Re: Initial Submission Review: 60th Avenue at Box Elder – Infrastructure Site Plan
Application Number: DA-1478-14
Case Numbers: 2024-6039-00

3RD SUBMISSION REVIEW

BOX ELDER INFRASTRUCTURE SITE PLAN

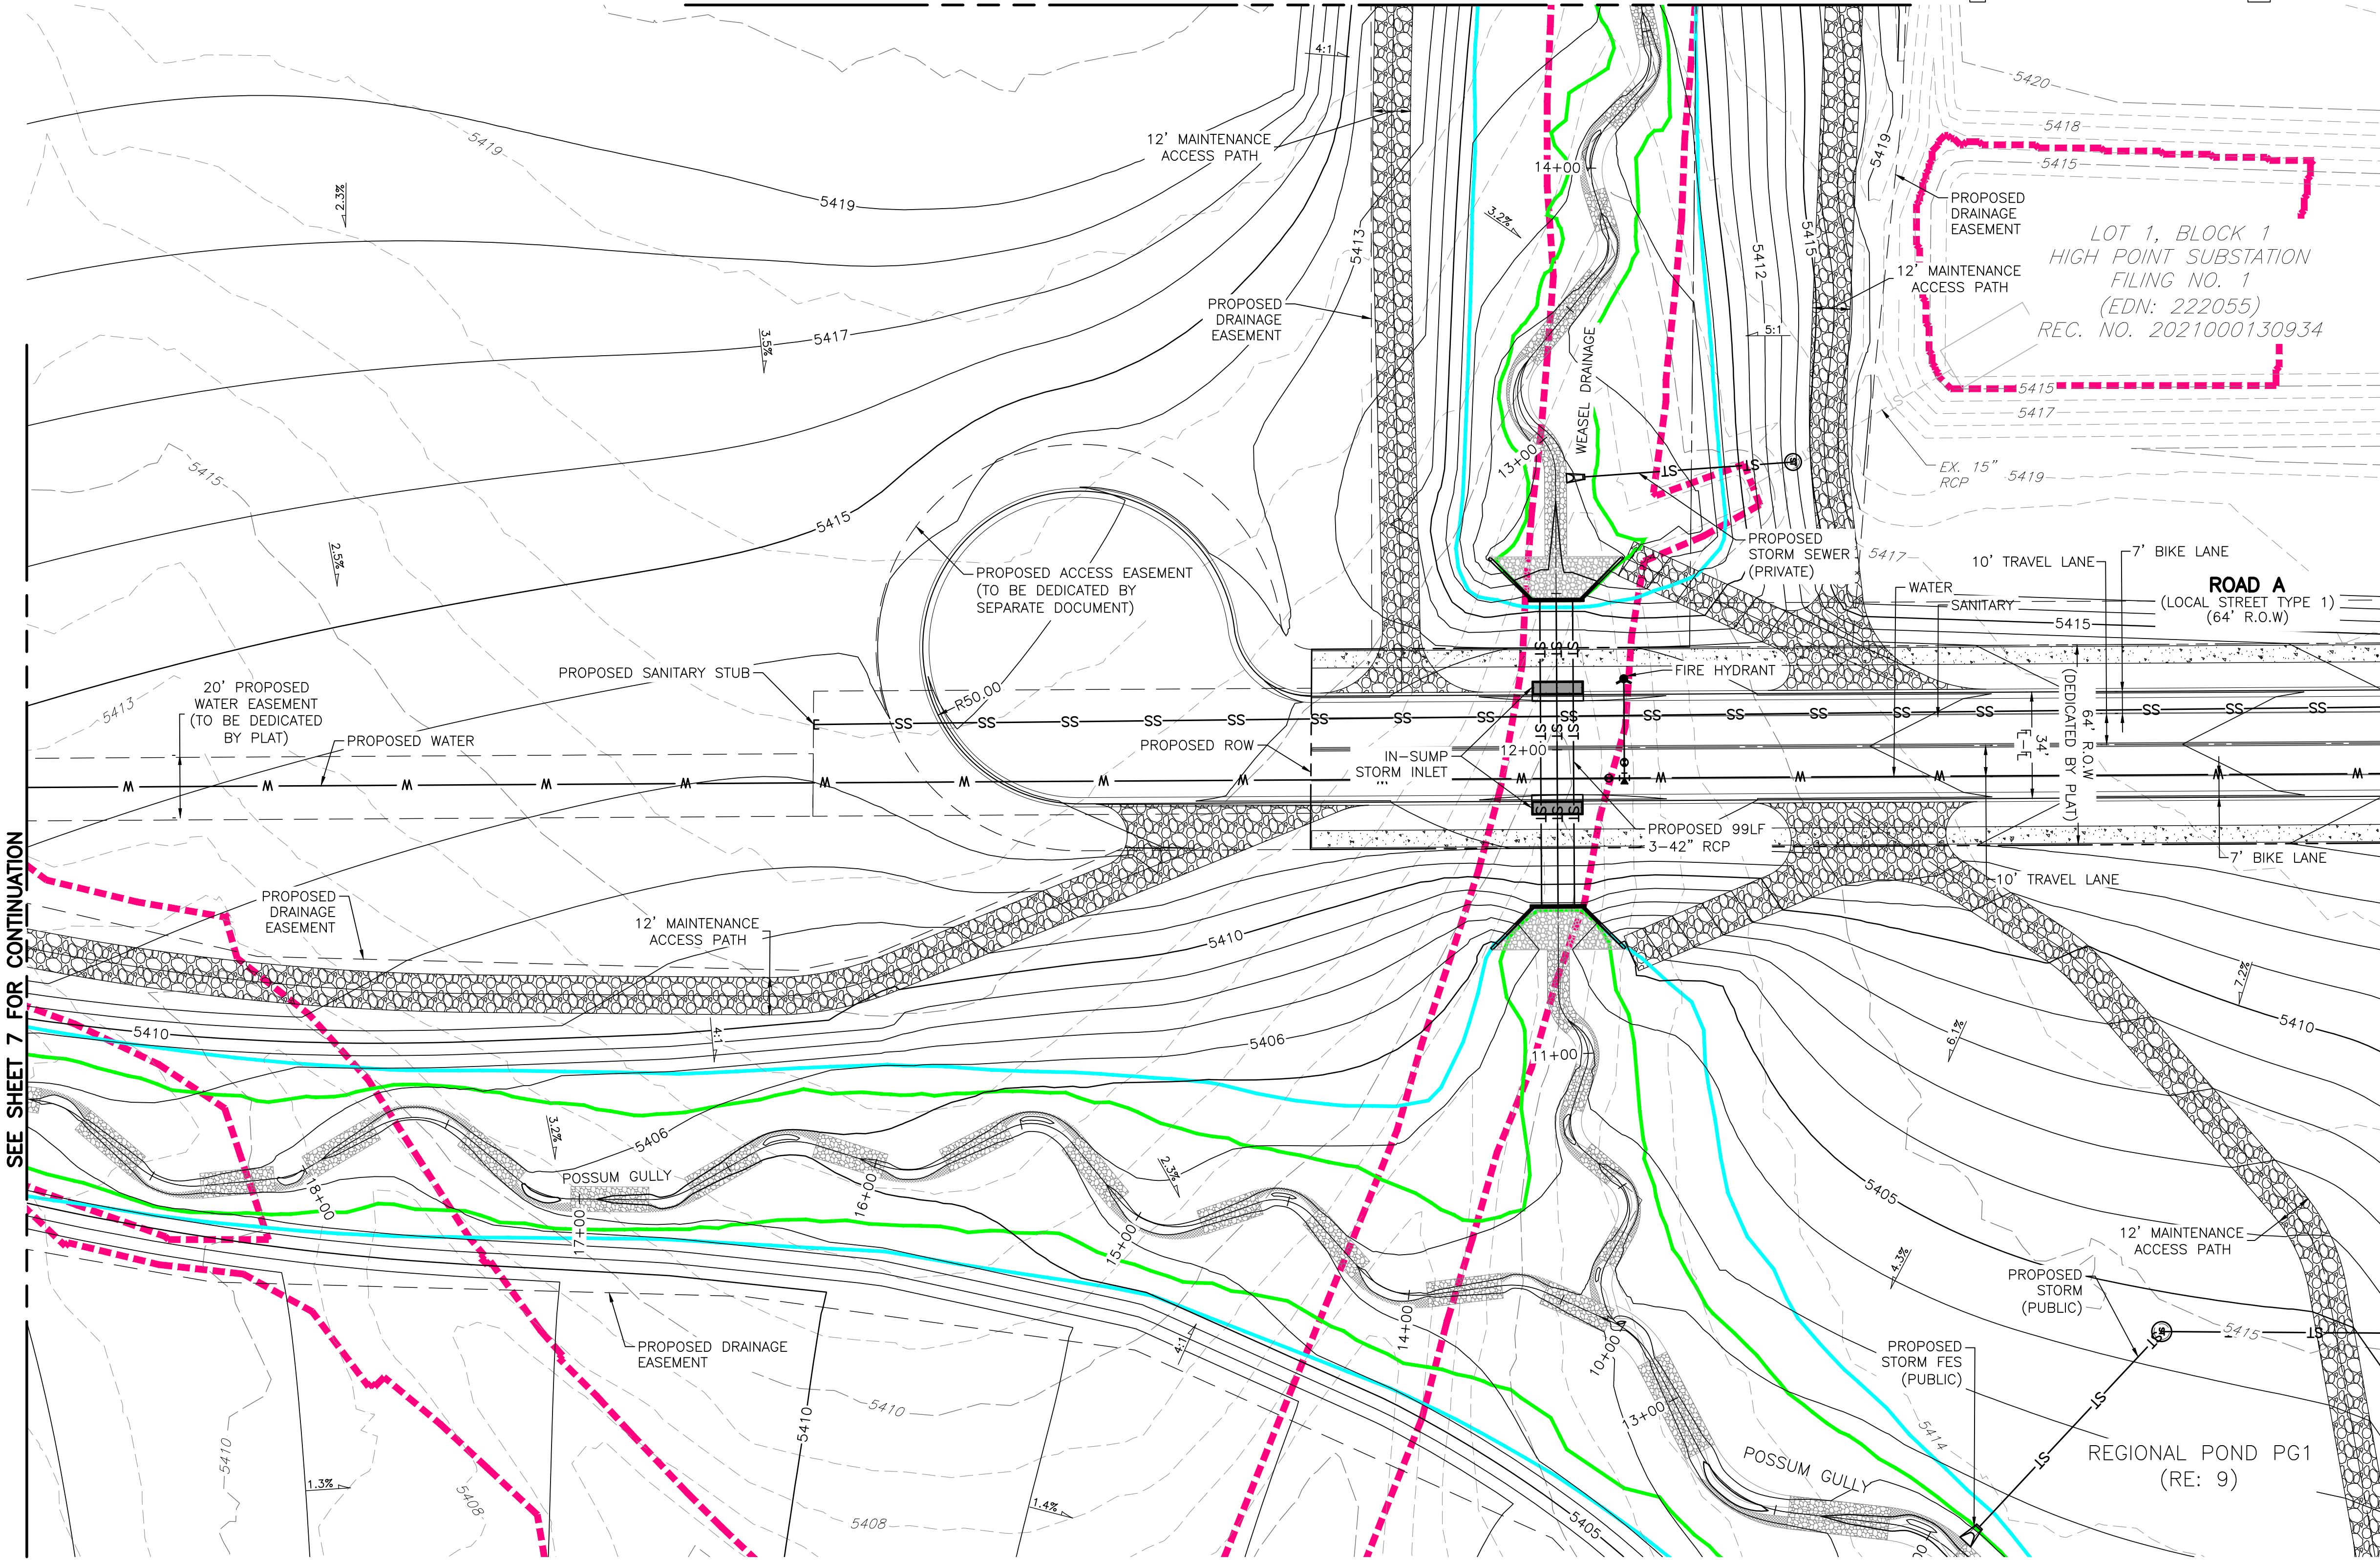
6F. Sheet 6: Sheet 5 is not a continuation of this area.

Sheet 5 is not a continuation of this area.

Response: *Sheet continuation callout revised*

SHEET REFERENCE UPDATED

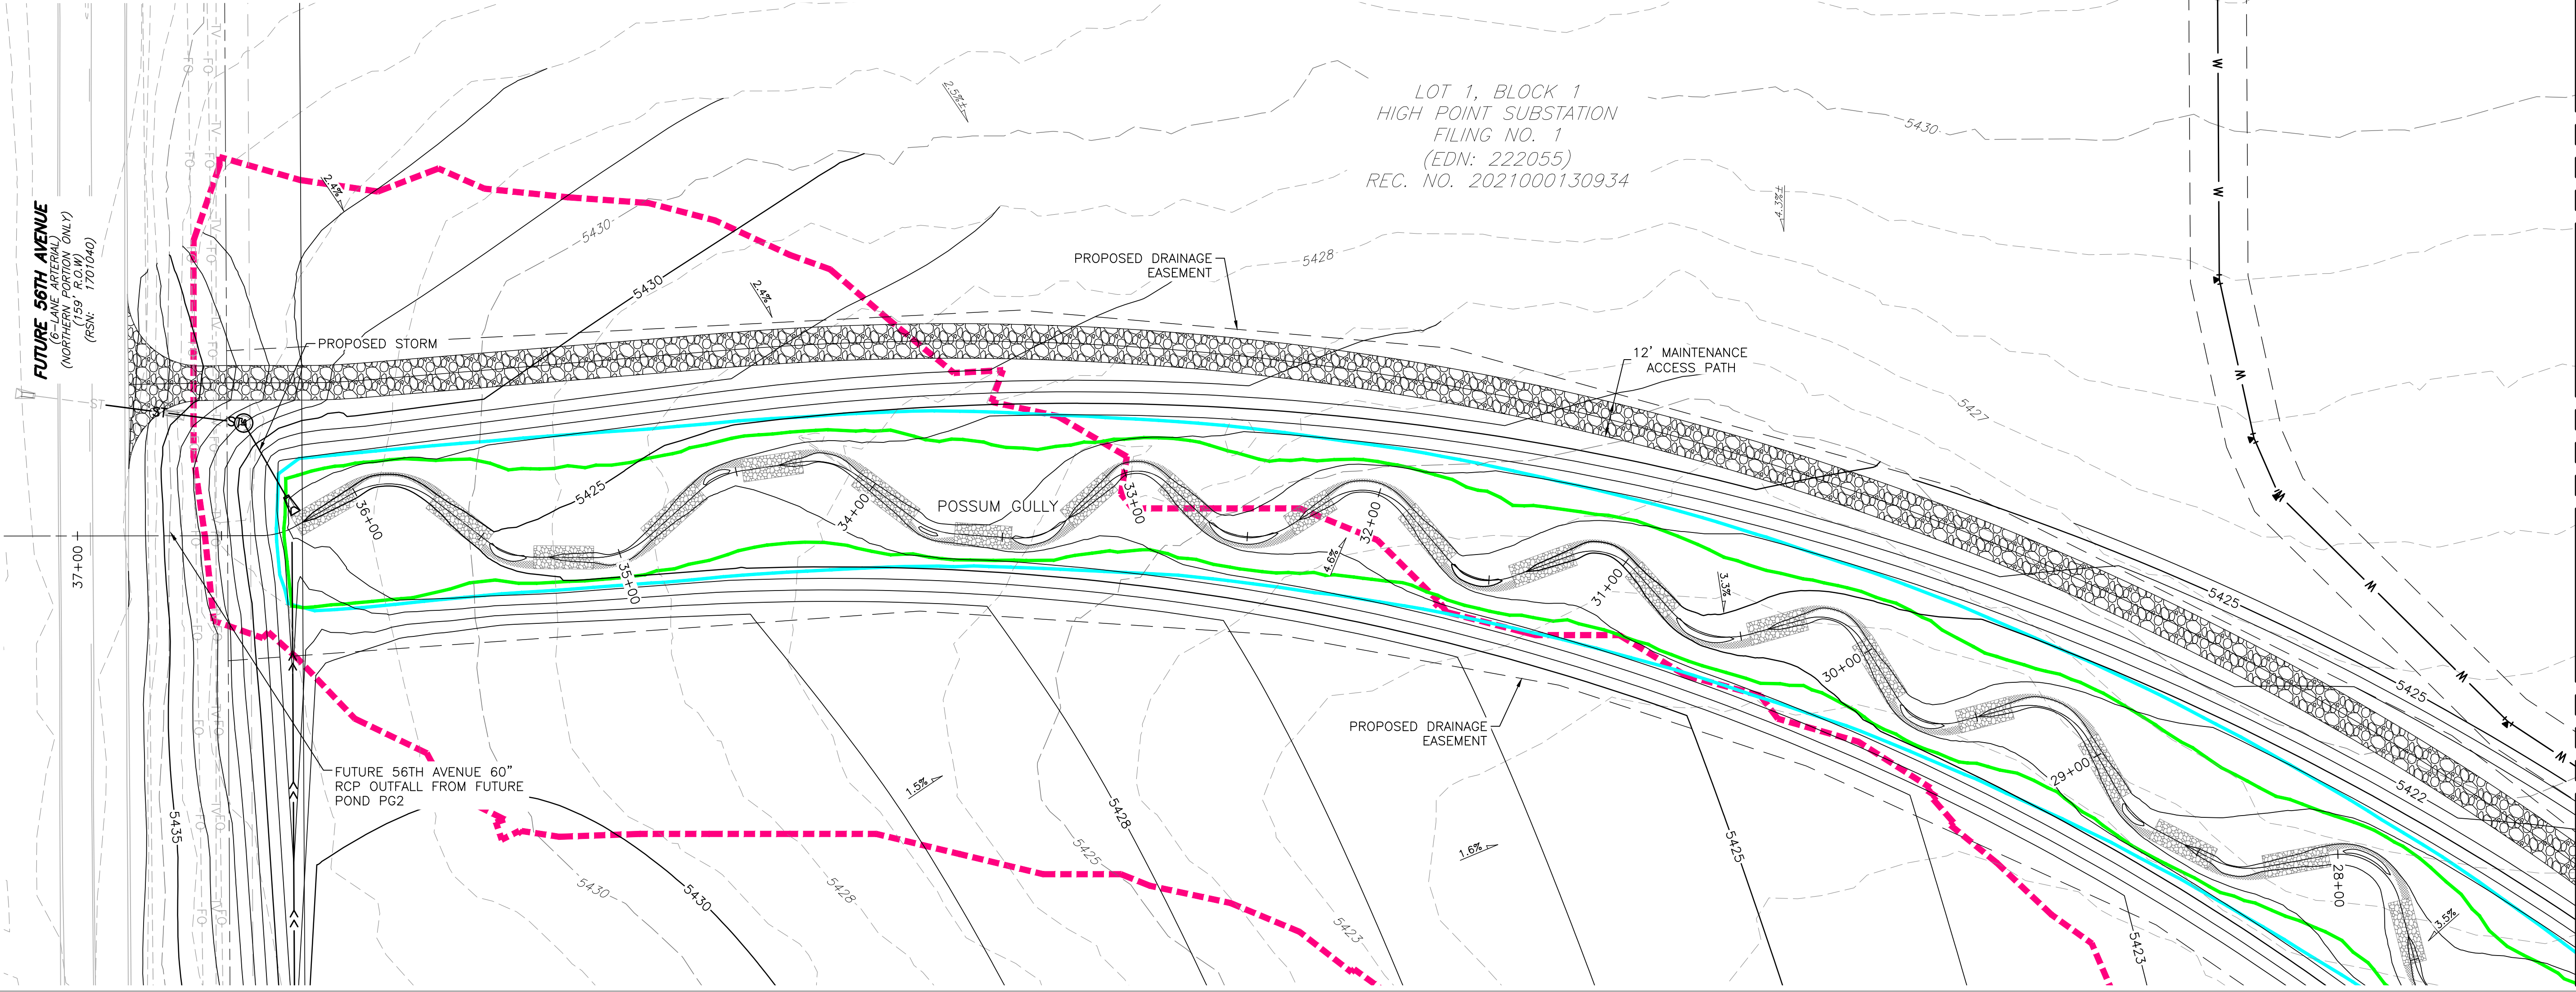
6G. Sheet 8: Show more detail of Tibet Road and the water connection.

Show more detail of Tibet Rd. and the water connection.

Response: *An additional viewport has been added to show water connection and Tibet Road.*

ADDITIONAL VIEWPORT ADDED TO SHOW WATER CONNECTION.
